SUBJECT: **DEMONSTRATION / DELIVERY HOLD – Application Performance Upgrade 11A01 – Supplement #1**
Certain 2011 Model Year Explorer, 2011-2012 Model Year Edge, MKX, and 2012 Model Year Focus Vehicles Equipped with SYNC® with MyFord/MyLincoln Touch™ Containing Early Vehicle Interface Processor (VIP) Level Software Performance Upgrade

REF: **DEMONSTRATION / DELIVERY HOLD – Application Performance Upgrade 11A01**
Dated March 5, 2012

REASON FOR THIS SUPPLEMENT

FIGURE 1

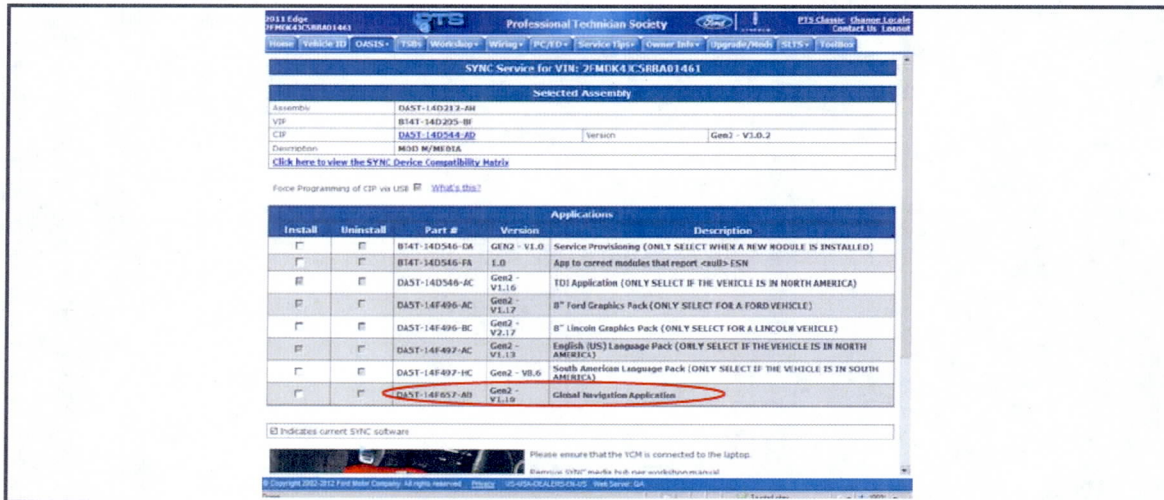
7. Scroll to the bottom of the screen, select "Standard" and click the "Read SYNC" button to compare the current APIM VIP, CIP, and application software levels to the last reported state in the Ford online database.

- After the compare is performed, the scan tool automatically selects software for programming. Applications with check marks next to them indicate the APIM already has the latest level installed (no re-installation required).
- Depending on the software level required, the scan tool automatically selects either the Service Pack or Full Flash programming method.
- For vehicles equipped with Navigation, verify that the Navigation application has been selected. See Figure 1.
